**CITY OF BOULDER
PLANNING BOARD AGENDA ITEM
MEETING DATE: November 3, 2016**

Project Name: Boulder University Inn Expansion
Location: 1600 Broadway
Size of Property: 0.54 acre
Zoning: BT-2 (Business – Transitional 2)
Comprehensive Plan: Transitional Business

DATE OF COMMENTS: **September 28, 2016**
CASE MANAGER: **Shannon Moeller**
PROJECT NAME: **Boulder University Inn Expansion**
LOCATION: **1600 BROADWAY**
COORDINATES: **N02W06**
REVIEW TYPE: **Concept Plan Review & Comment**
REVIEW NUMBER: **LUR2016-00070**
APPLICANT: **CHANCE REESER**
DESCRIPTION: **CONCEPT PLAN REVIEW AND COMMENT: Expansion of the University Inn involving removal of two commercial buildings, a new 41,606 square feet building with approximately 48 additional rooms, and installation of an underground parking structure.**

Figure 3 – Floodplain Map

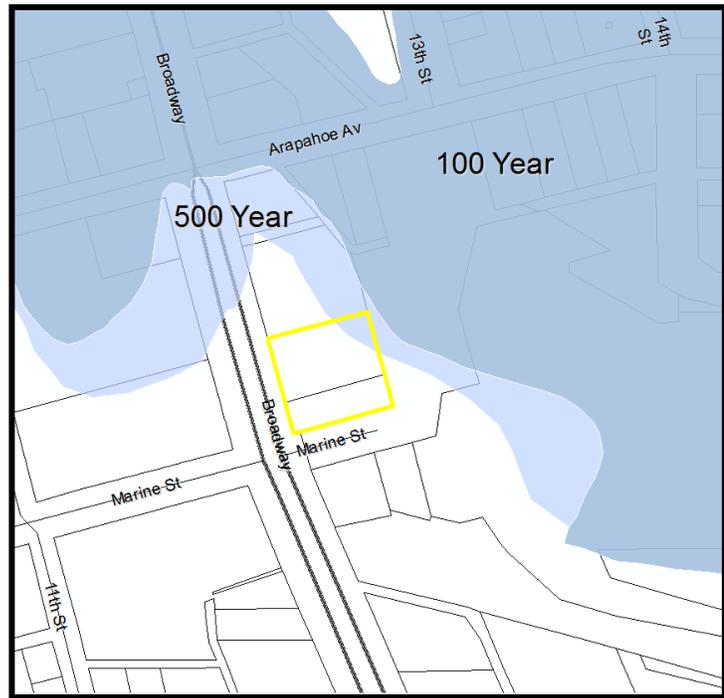
The site is part of a developed commercial property. The proposed structure is impacted by the 500-year floodplain of Boulder Creek. Lodging facilities are considered a critical facility and must comply with the development requirements of Section 9-3-2(i) of the Boulder Revised Code, 1981, including review and approval of an Emergency Management Plan prior to issuance of a Floodplain Development Permit.

Figure 7 – Site Sections

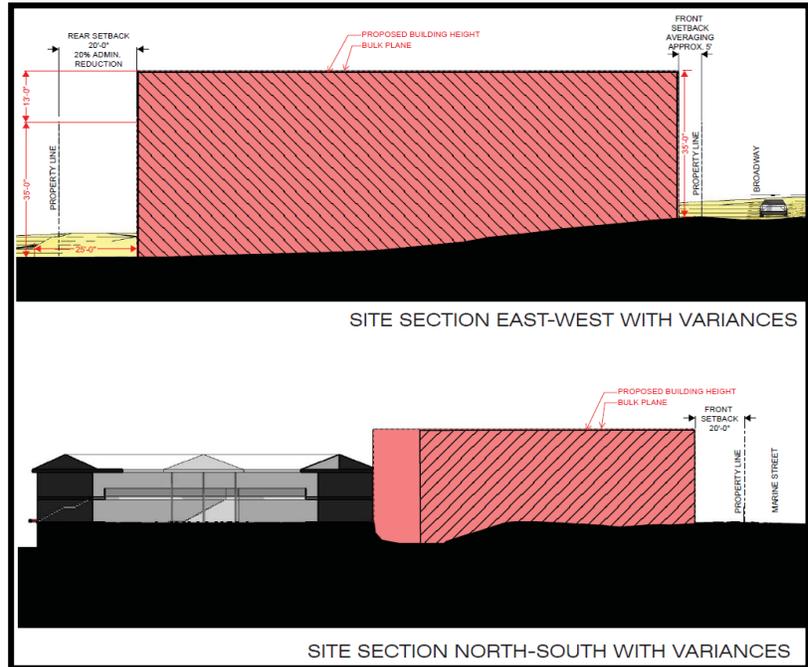
1. Sheet A-5 Site Sections: The low point appears to be greater than 25' from the proposed building. To identify the correct low point, find the lowest exposed point on the proposed building and draw a 25' radius. The lowest point within 25' is the low point. This point may or may not be within the property boundary. If this affects the resulting "height" of the proposed building, revise the site sections accordingly.
2. Sheet A-6 Massing Diagrams
 - a. Sheet states that 73 keys are added, but the application form states that 48 rooms will be added. Please clarify.
 - b. FAR calculations must include the parking facility floor area because the parking facility is not located completely below grade on all sides of the structure (refer to the definitions of "*Floor area*" and "*Uninhabitable space*" in section [9-16-1](#) General Definitions). Please update FAR information accordingly.
